## RENOVATION OF DEPARTMENT OF MOTOR VEHICLES INSPECTION STATION AT HALF STREET, SW (PHASE II)

## Addendum No. 2 Issued: May 1, 2017

This Addendum No. 2 is issued on May 1, 2017 via email to answer questions raised by vendors.

30A

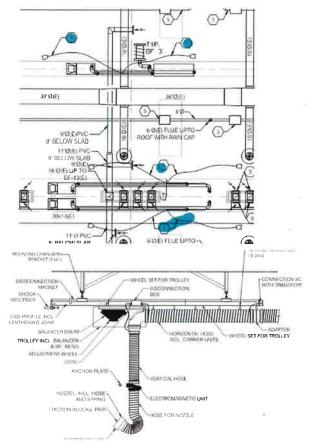
In reference to the replacement of exhaust hoses, the regional representative for Monoxivent has advised us that more information is need to provide a price quote for the replacement of the (6) Hoses. The model of hose and length of existing hose must be provided in order to provide a price. Can this be provided.

Hose shall be series 7120, contractor shall carry price for 15 feet of hose. Hose reel with spring return and tail pipe adapter shall be provided. Only two stations have this hose (not six).

Spring Retractable Hose Reel Series 9000

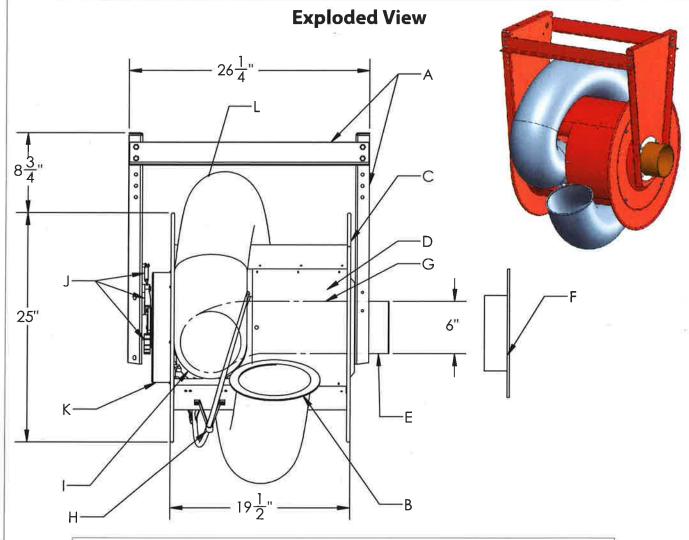
7	On Drawing M501.2, Key Note #1, the detail on the drawing does not match existing equipment. Provide a model number for Monovixent, which is identified as the Basis of Design.	See attached PDF and hose reel with spring return shall be provided.
8	On Drawing M101.2, provide the natural gas pipe size (which is price sensitive) and tie-in points to each of the 7 IGH's.	See attached for clarifications on P101.2 and new sheet P501.2
9	On Drawing MD101.2, Demolition Key Note #2 states that the contractor should replace any inoperable radiant heaters. Does the government know if all radiant heaters (100%) are currently functioning and considered operable? If not, how many are inoperable? Would it be prudent to create an allowance for repair of any elements of the heating system found to be inoperable?	It is currently considered as functioning.  Contractor shall provide bid alternate for every radiant heater that need to be replaced.

**SK01**

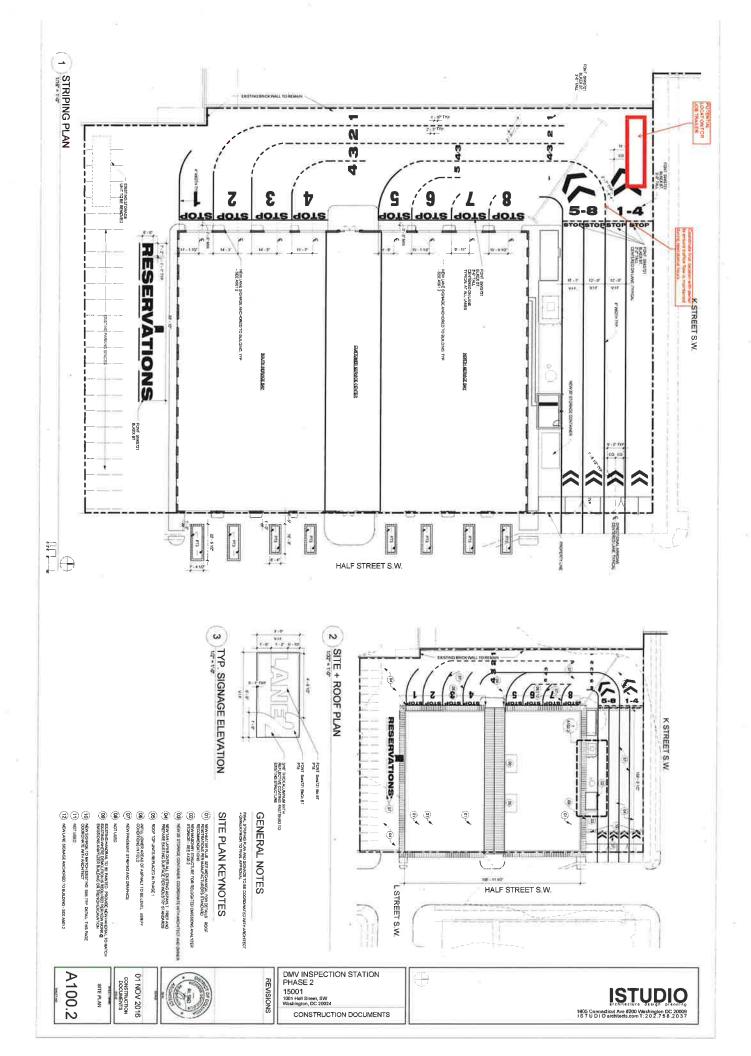
THE FOLLOWING DETAIL IS IN REFERENCE TO THE SITE CONDITIONS OBSERVED AND DISCUSSED DURING THE PRE-BID CONFERENCE ON 04.19.2017. THE EXISTING CONCRETE SIDEWALK AT THE SERVICE LANE EXITS (EAST SIDE OF BUILDING) HAVE SETTLED, CREATING A TRIPPING HAZARD. ANGLED STEEL TRANSITION STRIP SHALL BE INSTALLED AS DETAILED BELOW.

GC SHALL FIELD INSPECT AND VERIFY ALL CONDITIONS AND DIMENSIONS PRIOR TO INSTALLATION.
